19 June 2015
Ref: GS1302.27

***DA T6-14-62 Subdivision
Part Lot 35 DP 1167775
Waianbar Avenue, South West Rocks***

The purpose of this letter is to respond to the issues raised in the order identified in Council's letter to assist the Joint Regional Planning Panel to appreciate the manner in which each issue has been addressed. The issues are addressed as follows:

Project No.	13056
Drawing No.	DA-10
Amendment No.	DA5

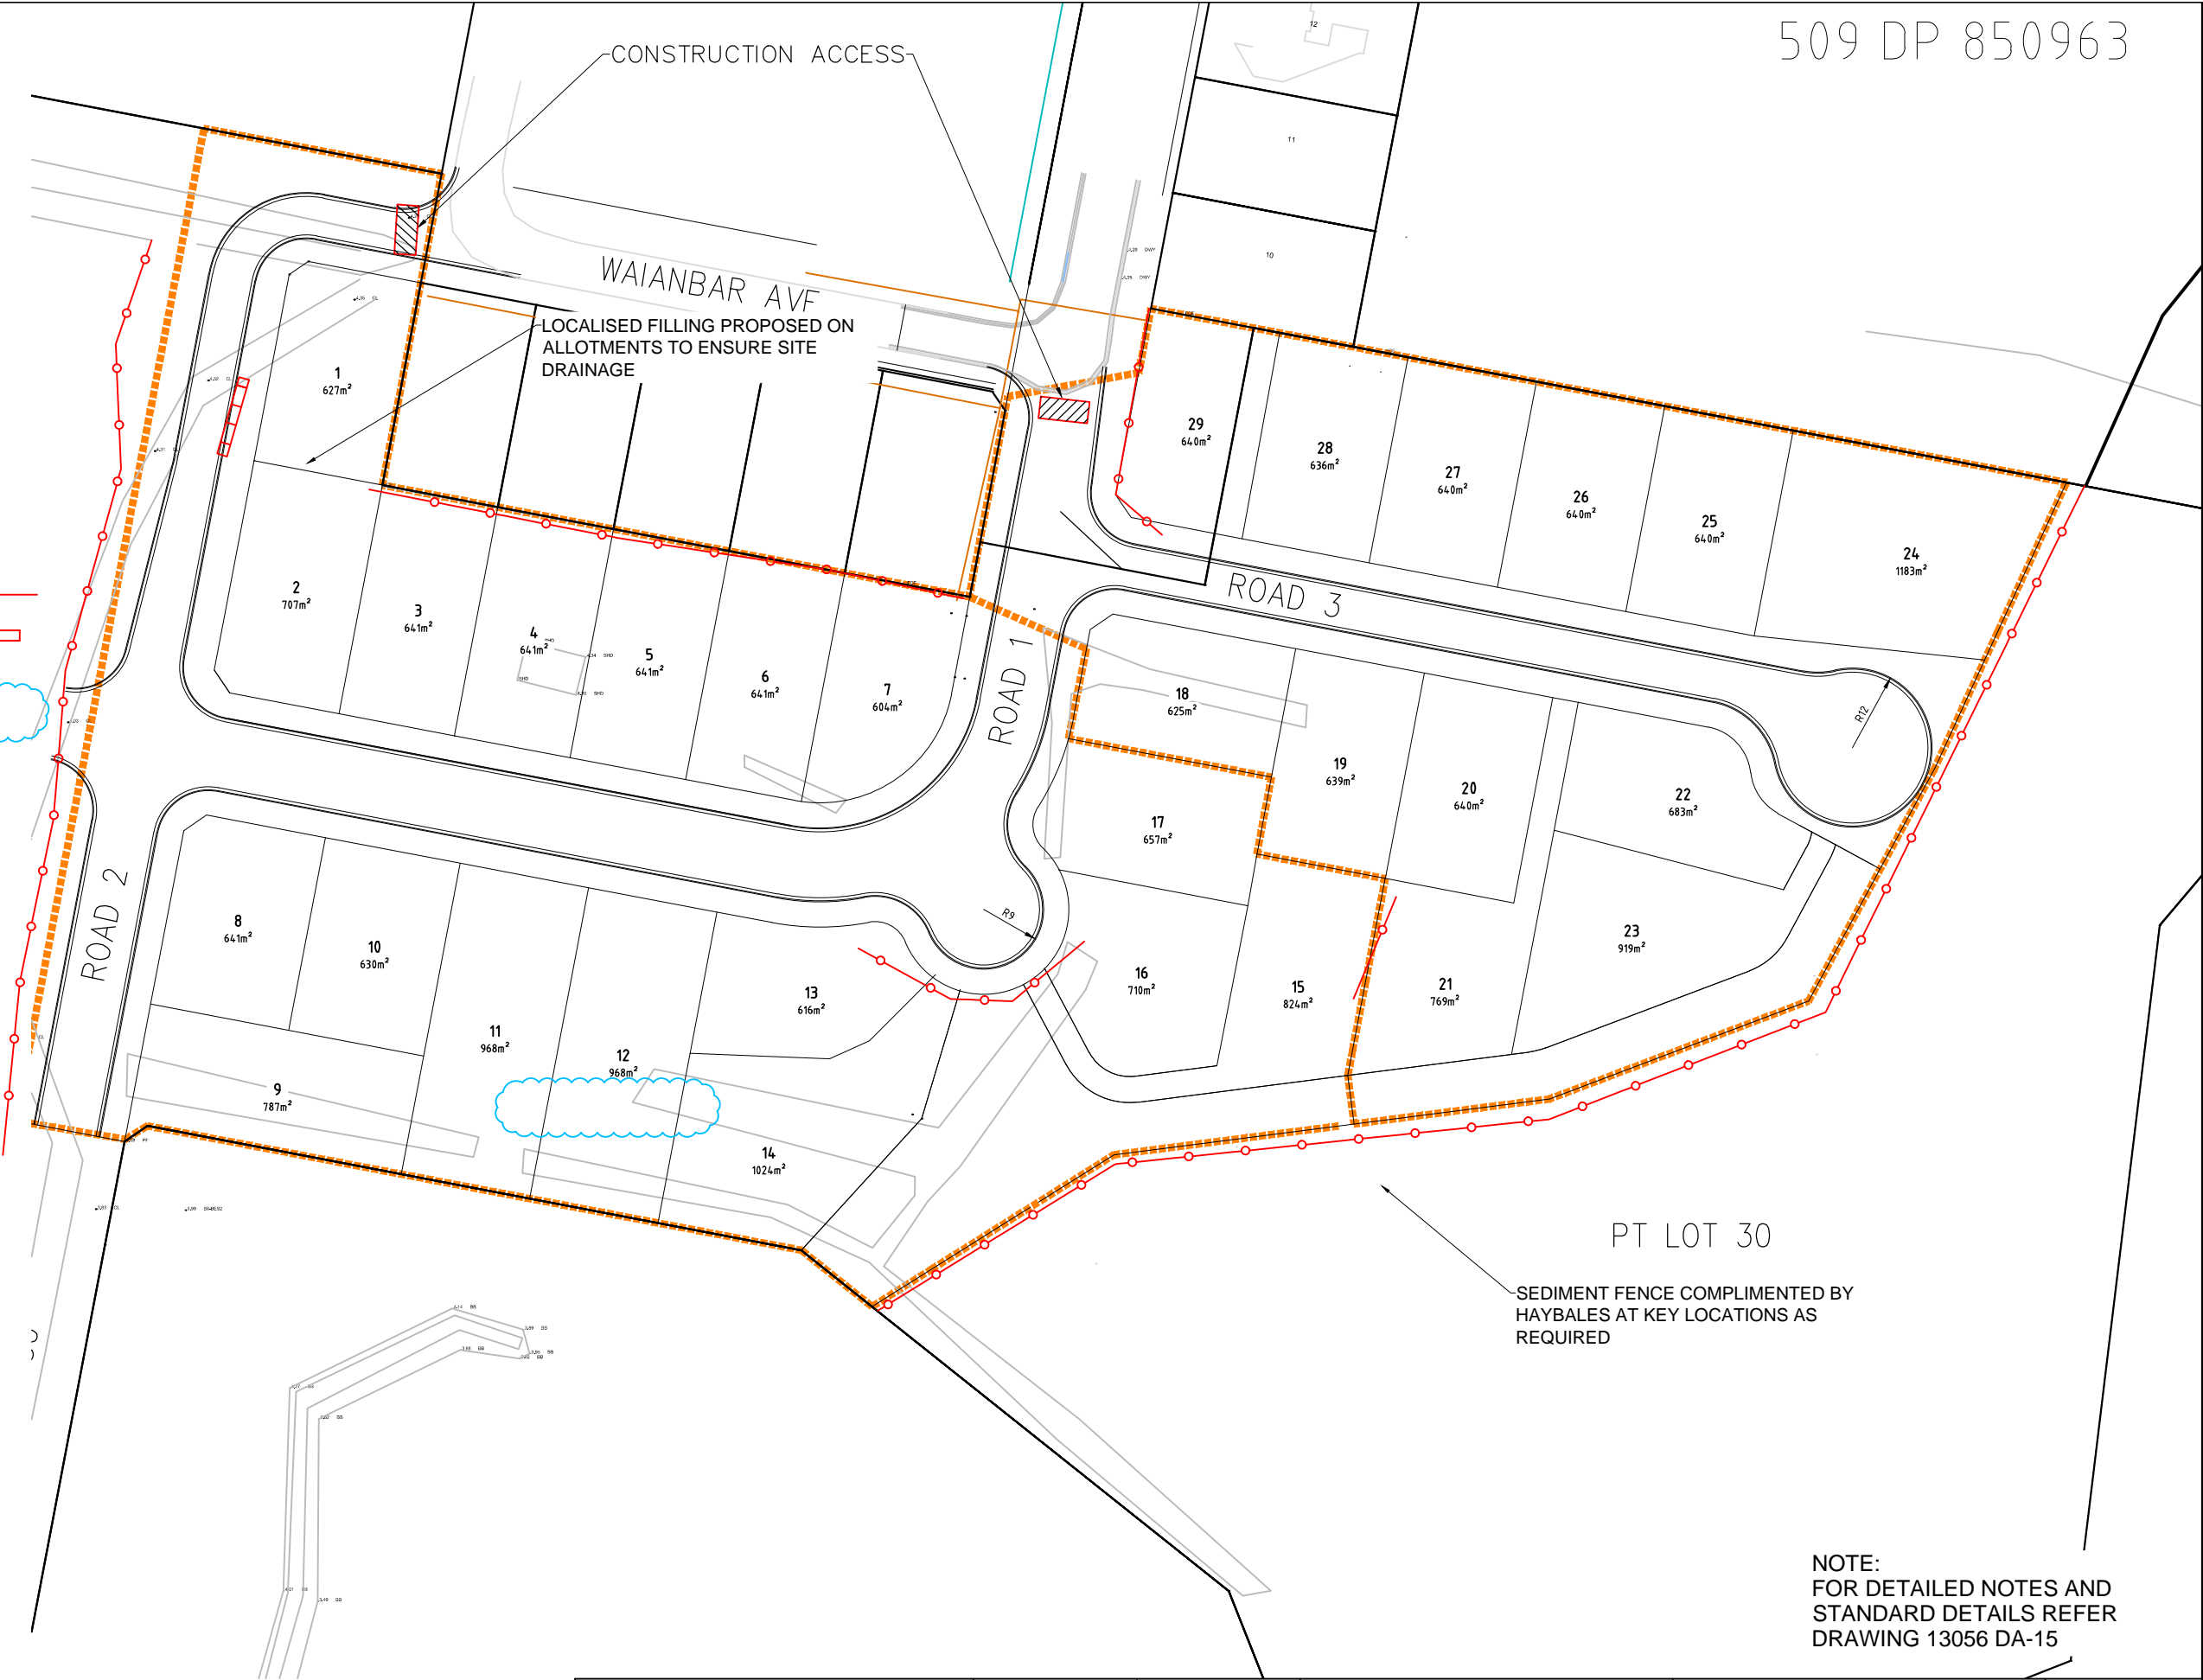
Comment: Discussions have been held with staff of the Service and a fire trail access is now proposed as the agreed solution. An amended subdivision plan is attached in Annexure A to this letter. This plan is supported by RFS however it will be necessary for Council to seek the formal written support of the Rural Fire Service as the Council is the referring authority.

Comment: The Rural Fire Service is now satisfied with the fire trail access for Stage I in accordance with the amended subdivision plan enclosed in Annexure A. Perimeter roads are generally provided throughout the concept plan area with the exception of two cul-de-sacs in the west. These cul-de-sacs can be eliminated and a perimeter road provided as a condition of consent for the future subdivision of the concept plan area.

Title: STORMWATER MANAGEMENT PLAN	Project No. 13056
	Drawing No. DA-16
	Amendment No. DA4

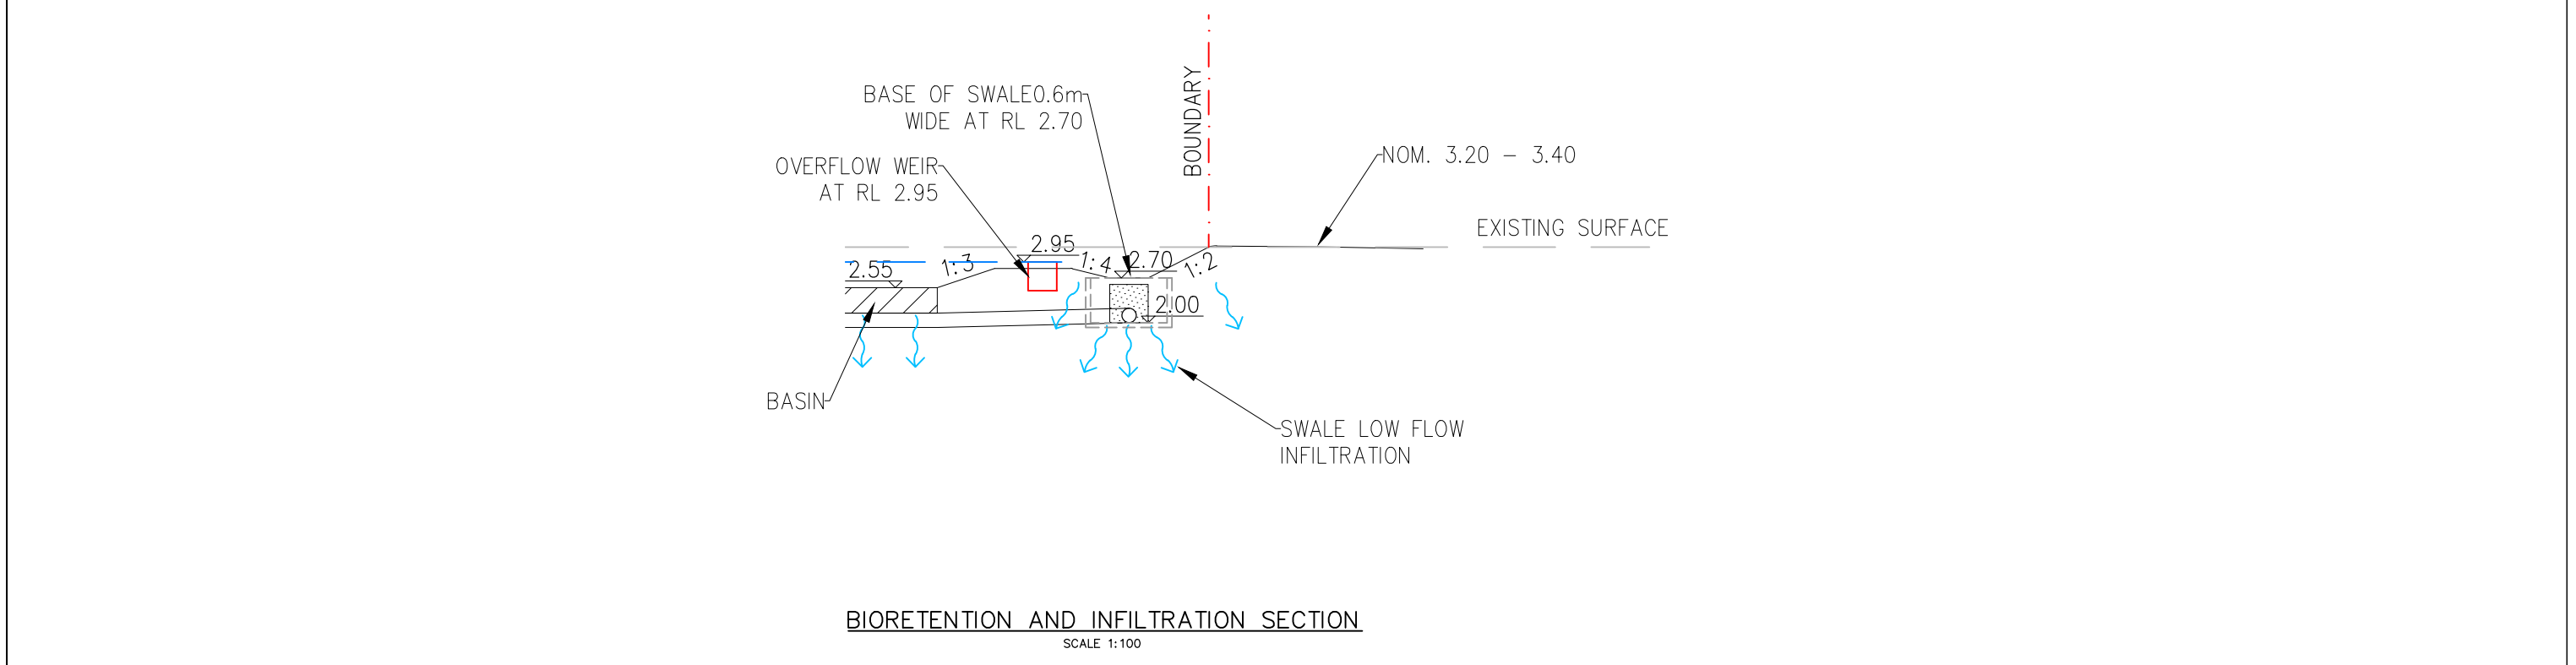
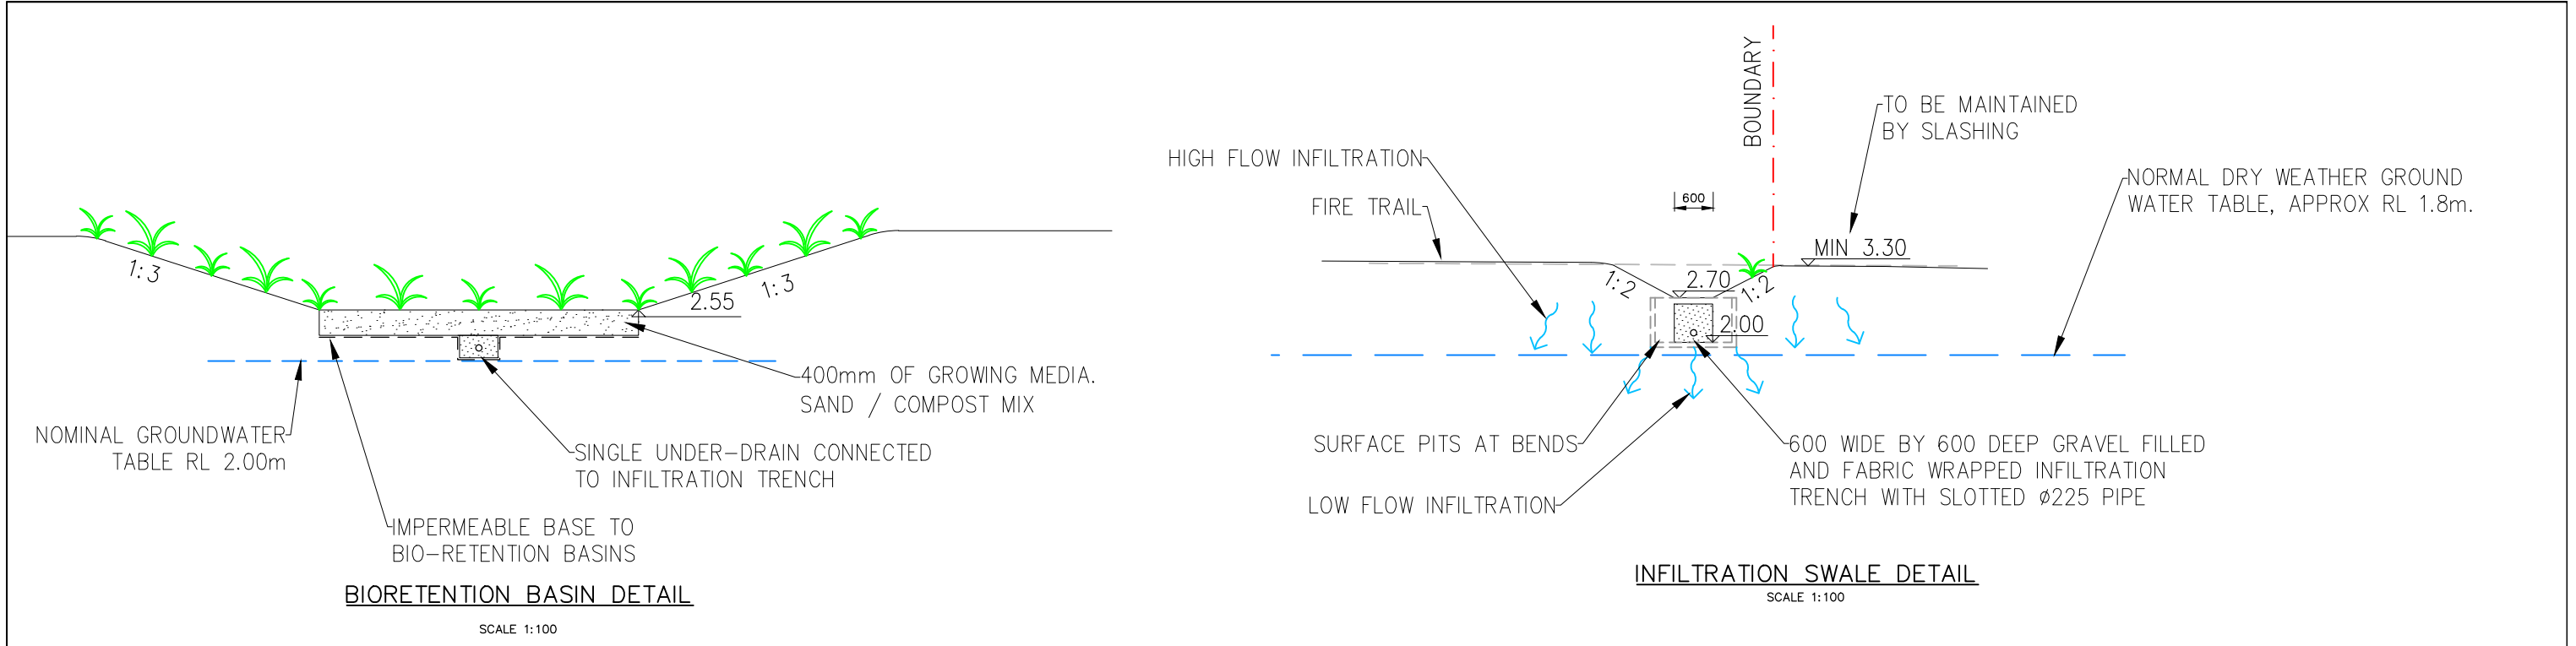
Some additional stormwater modelling has been undertaken by de Groot and Benson and the findings are included in the addendum report in Annexure B. A plan included in Annexure B identifies the proposed locations for stormwater run-off controls as well as water quality controls for the concept area of the site in future stages to minimise any impacts from stormwater leaving this site after development. The location of these controls will be wholly within Zone R2 and the anticipated area required to accommodate these controls is also identified on the plan.
